Service Counselor

PACKARD DIVISION
OF
STUDEBAKER-PACKARD CORPORATION

VOL. 29, NO. 12

NOVEMBER 15, 1955

Fig. 1

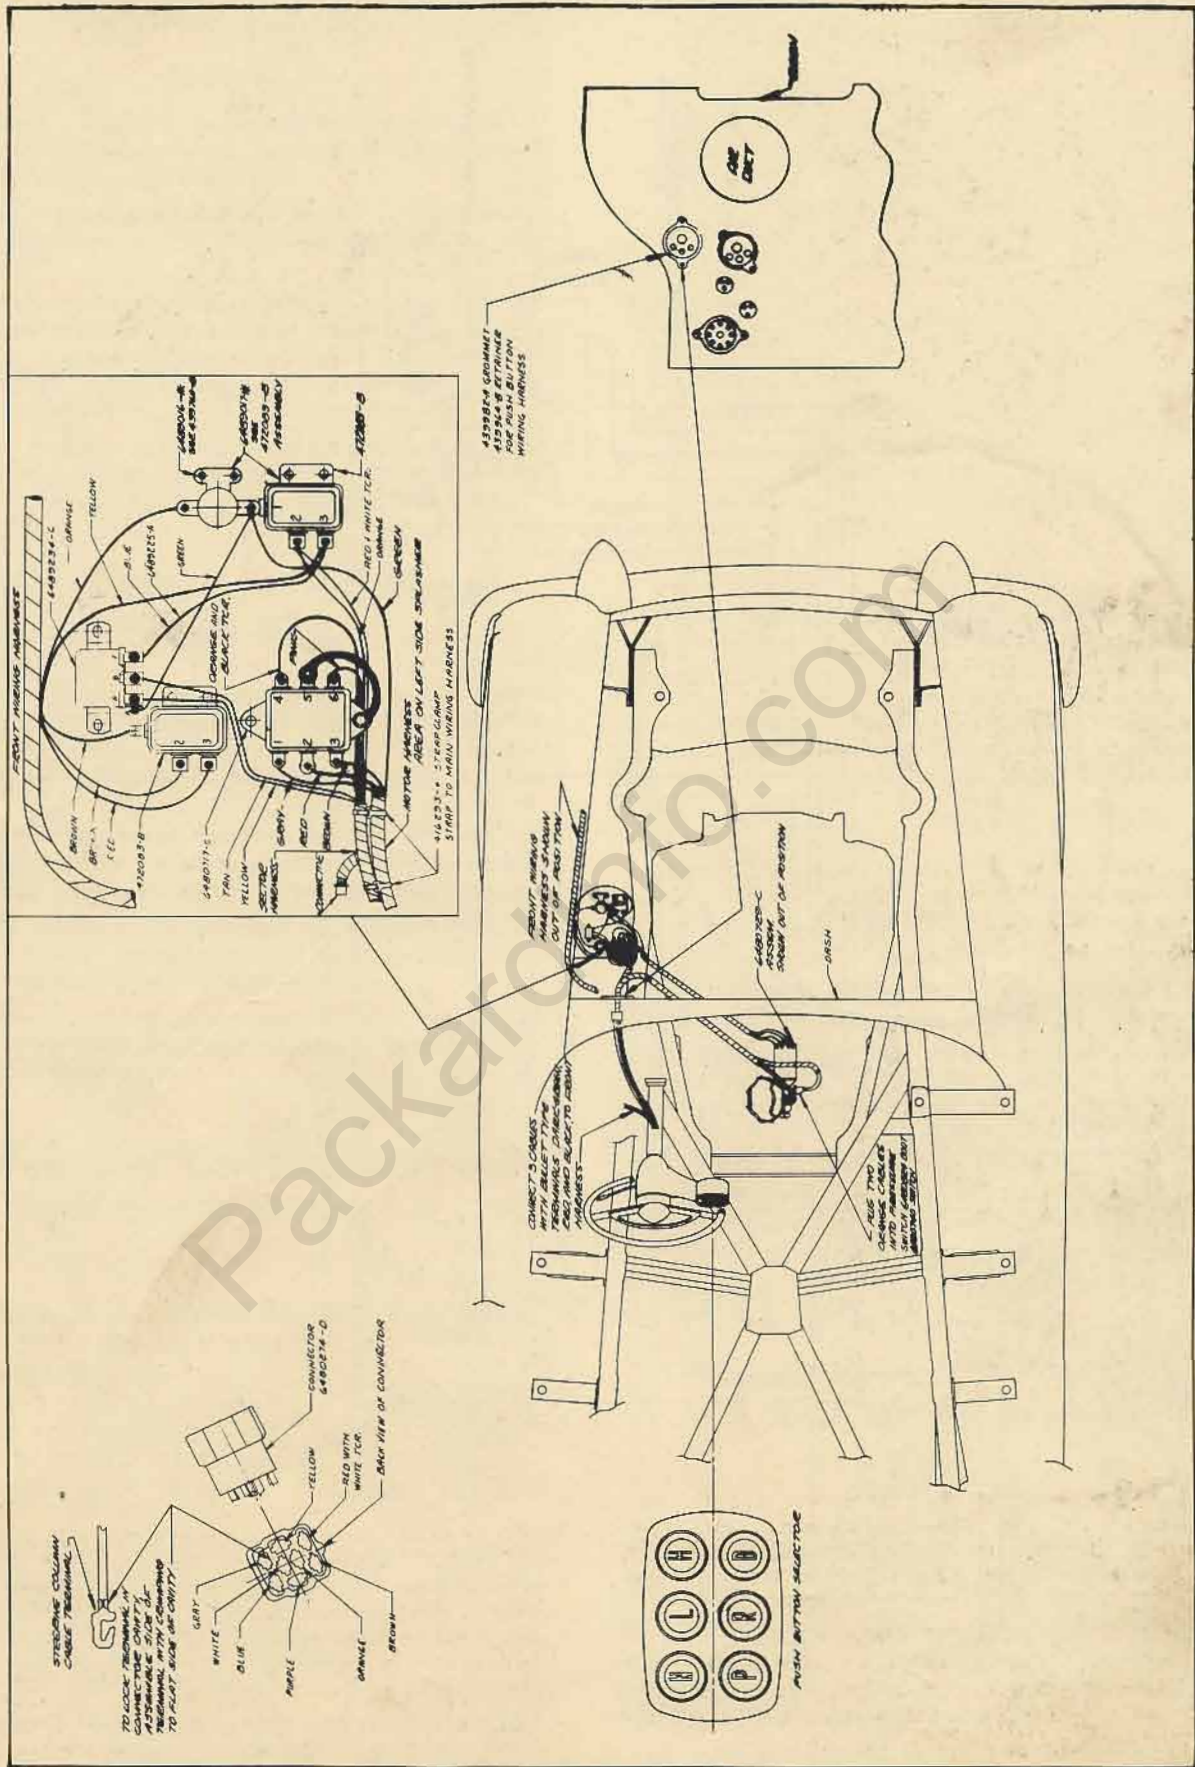
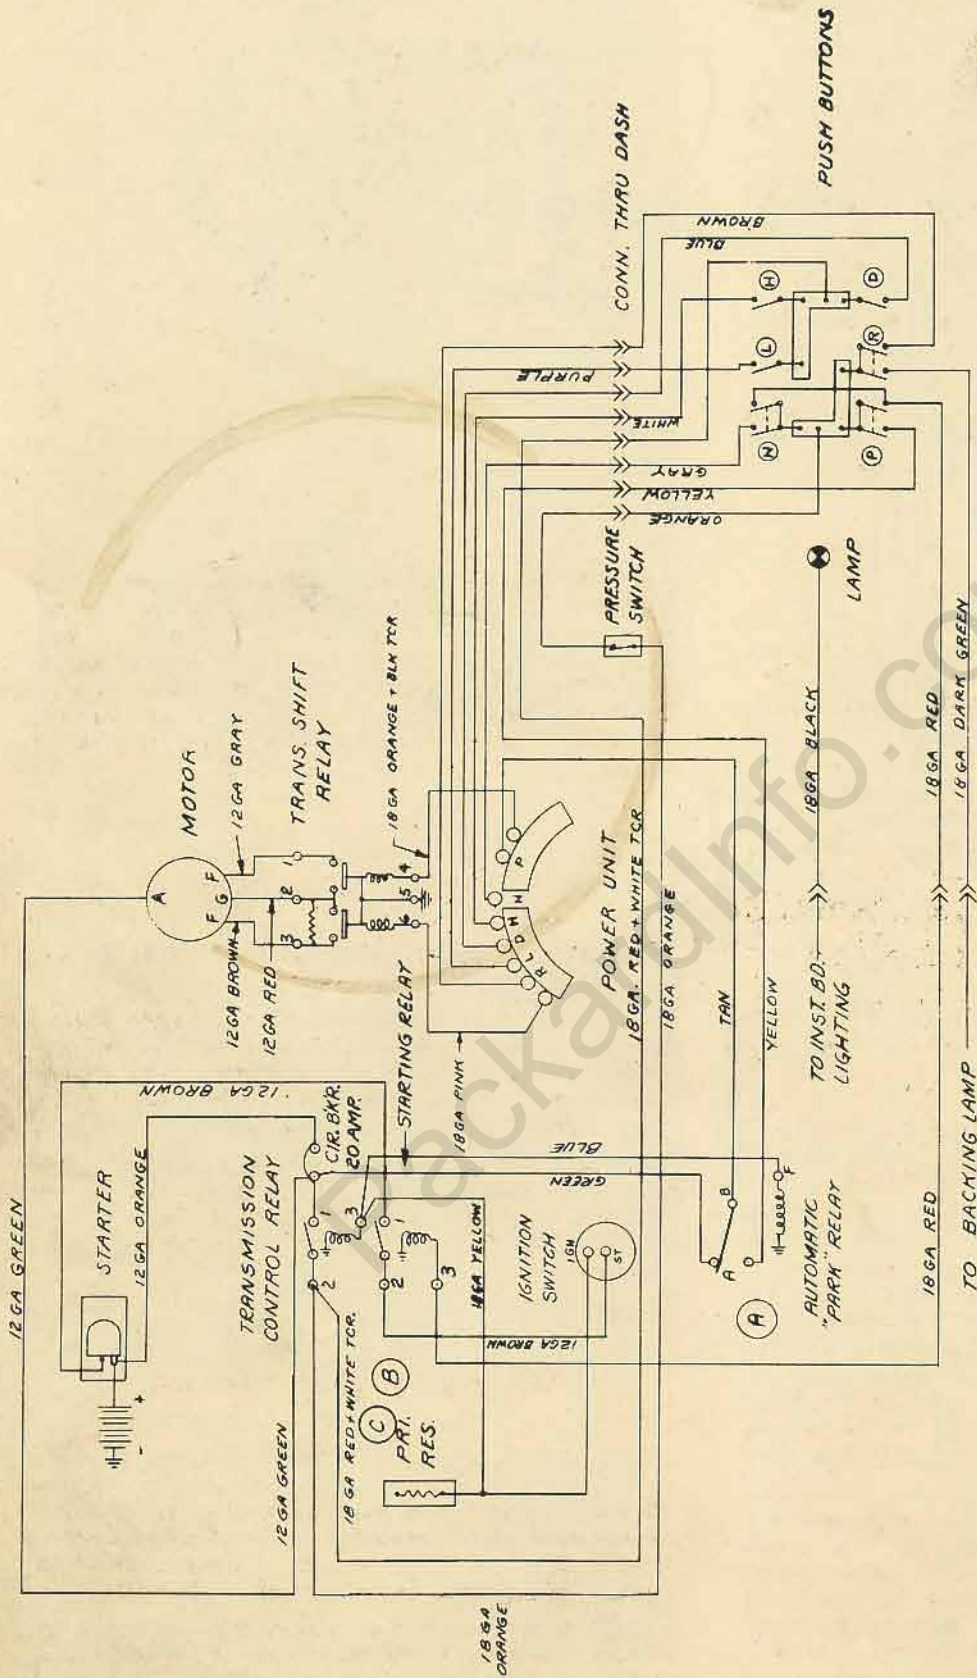
Since the writing of the Ultramatic Push Button Control article in Service Counselor Vol. 29, No. 11, November 1955, Engineering has incorporated an added safety feature which started with the first 56th Series production cars.

By adding a relay and changing the wiring slightly, the Transmission automatically goes into "Park" when the ignition switch is turned off.

Disregard the two wiring diagrams figure 7 and 8 in the November Counselor and use the wiring diagrams in this Counselor when referring to the electrical circuit.

When removing the transmission control actuator and motor assembly, it will be necessary to disconnect two additional wires (yellow and tan) from the upper relay No. 6489234 shown in figure 1. The other wires to disconnect are described in the first paragraph on page 58 of the November Counselor.

Carburetor Throttle Control Shaft Lever Extension

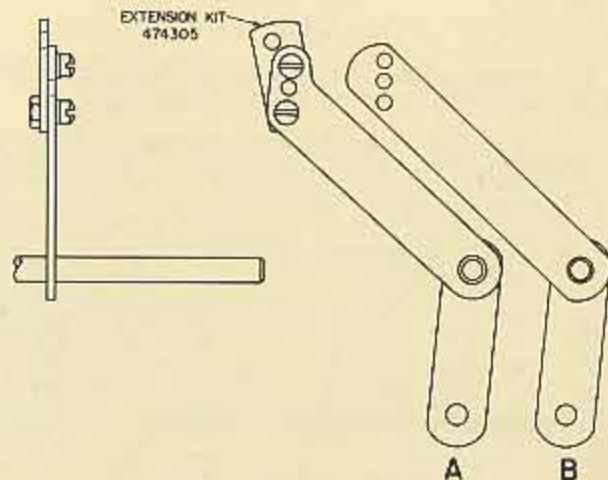
The 55th Series Ultramatic Transmission was installed on the first production 5640 models when so equipped (transmission serial numbers 5-39010 through 5-40510). The throttle lever extension shown on the lever "A" in the illustration was also used.

56th Series cars having transmission serial numbers A-1001 through A-2101 were equipped with 56th Series transmissions but still have the 55th Series throttle lever "A." Some of these cars may have the extension on the lever and some may not depending upon whether unwanted kick-down was encountered.

All 56th Series cars having Ultramatic Transmission Serial numbers after A-2101 will have the throttle lever as indicated by "B" in the illustration which does not require the extension. The carburetor throttle rod should be installed in the center hole of the lever unless unwanted kick-down is encountered, then install the rod in the upper hole and readjust the linkage.

If unwanted kick-down is encountered on the 56th Series cars (56th Series Transmissions with the 55th Series lever), we suggest that you install the extension kit Part No. 474305 and readjust the linkage properly.

Auto-Lite Generators

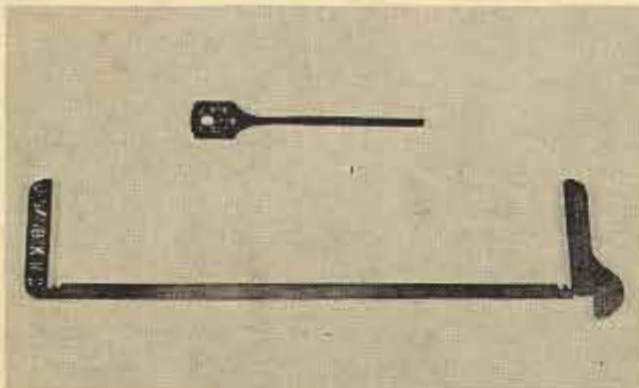
Due to a temporary shortage of 56th Series Auto-Lite Generators Part No. 6480145, model GJC-7002, production has installed a few 55th Series Auto-Lite Generators Part No. 439593, model GJC-6001.

The generators are identical parts wise and the only change is the polarity which was changed to coincide with the negative ground battery.

The name plate on these generators have not been changed, however, they can be identified by a dab of white paint on the face of the generator.
